HISTORIC DISTRICT REVIEW BOARD MEETING AGENDA

MEMORANDUM

Subject: HDRB #22-010, 700 Street, Suite B, Projecting Sign

Subject: HDRB #22-013, 783 Station Street, Herndon Virginia

SIDE 1

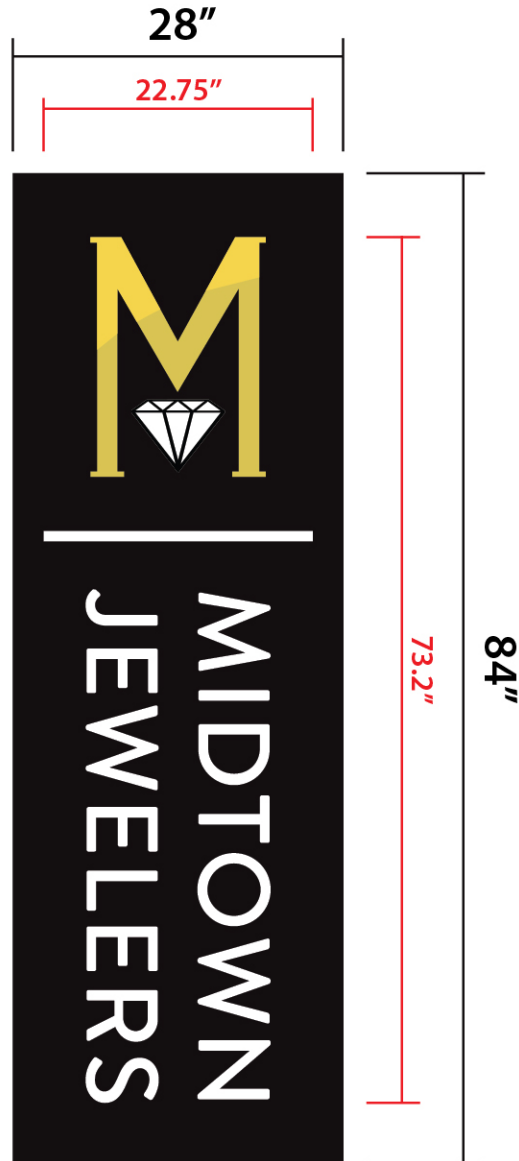
Sign size and dimensions. Updated sign documents provide details for the dimensions of both sign faces, the smaller consisting of 16.33 square feet, and the larger 19.8 square feet. The sign was originally presented as a 21.33 square foot sign (showing dimensions for the smaller side only) after which the smaller side was decreased to 16.33 square feet with the larger side at 19.8. Staff notes that on page 2 of the attached Updated Sign Drawings, the width of the smaller side of the sign is noted as 12 inches instead of the proposed 28 inches.

Staff believes that overall, the sign can be considered appropriate for this location with the 5SF reduction in size proposed by the applicant and is generally supportive of blade signs within the Historic District. Staff is recommending approval of this sign with conditions.

- 1) The applicant shall provide updated design documents clearly stating that the sign letter faces and logo face will consist of the same metal material provided to staff as a sample prior to submission of the building permit.

32" X 96" SIGN = 21.33 SQ FT

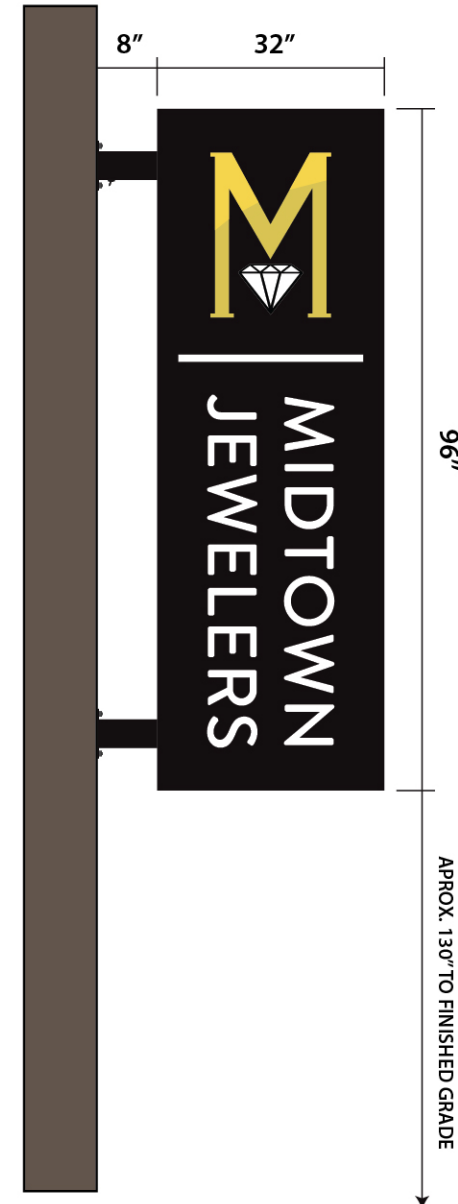
Staff also requested that the sign measurement on the updated documents reflect the zoning requirement of using the larger sign face to measure square footage. Following the work session, the applicant and staff discussed options for moving forward and staff provided feedback and clarification regarding the Board's requests.

The applicant has provided updated drawings. The updates do not include a reduction of the sign to the 12 square feet and do not use the larger angled face of the sign for size calculation. They do include a rendering of the proposed sign looking east and clarification regarding the letter return depth (1/2-inch visible returns). The applicant

Staff is concerned with the overall massing and visual impact of the sign. As proposed, the sign projects a little over 3 feet from the building façade and the sign itself is 8 feet tall. This, combined with the triangular shape of the sign, creates a substantial impact to building façade.

At this time, staff is withholding a recommendation pending submission of revised drawings with the measurements of the angled side of the sign, and call-outs for the cut metal letters instead of push-through acrylic.

(1) D/F ROUTED HANGING SIGN**Produce to Replace:**

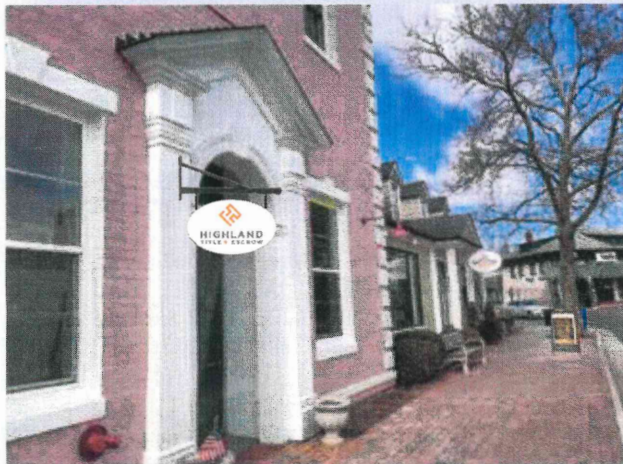
- e. The proposed sign location does not fit logically within the architecture of the building.
 - f. The submitted drawings do not give a height measurement for the projecting sign. The Downtown Pattern Book states that signs should be situated at a minimum of 8-foot clearance from the sidewalk.

5. The location of the projecting sign as proposed with the bracket attached to the fluted pilaster portion of the door surround is not an intuitive placement architecturally. A more appropriate placement would be on the façade of the building to the side of the door surround. Staff suggests that this modification to the placement be made prior to an approval by the Board.

6. Staff is asking the applicant to address the following questions prior to a recommendation from Staff:
 - a. Provide a measurement for the sign clearance from the sidewalk. If below the 8-foot minimum recommended in the Downtown Pattern Book, alter and provide updated drawings to staff.

- b. Modify the placement of the projecting sign to be attached directly to the building façade instead of the pilaster.
 - c. Provide an updated full page, to scale rendering of the proposed wall sign on the building façade. This should include a measurement of the building frontage.

- 1) This approval excludes the proposed wall sign.
- 2) The applicant shall provide updated, full page to scale renderings of the projecting sign in its updated position affixed to the building façade instead of the door surround for staff review, prior to applying for the building permit.
